SIGIR PA-06-071 JANUARY 08, 2007

SUBJECT: Report on Project Assessment of the Al Kasik Water Storage Tanks, Al Kasik Military Training Base, Al Kasik, Iraq (Report Number SIGIR-PA-06-071)

Al Kasik Water Storage Tanks Al Kasik Military Training Base, Iraq

Site Photo 15. Diesel penetrated the welds within 24 hours of test.

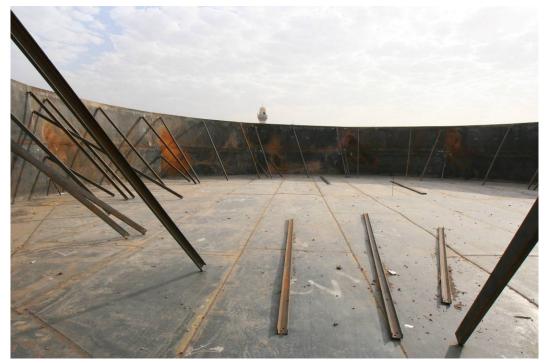
After the first two runs were completed, a diesel penetrant test was performed to determine if the welds held a seal. That test consisted of application of light diesel fuel (kerosene) to the weld's surface. Penetration of diesel through the weld indicated failure or leakage. Procedures dictated that all leaks would be repaired and retested. Site Photo 15 shows where the diesel fuel passed through the weld after a 24-hour dwell² period on the outside of the tank. Site Photo 16 reveals a leak in the inner weld of the after the 24-hour dwell period.
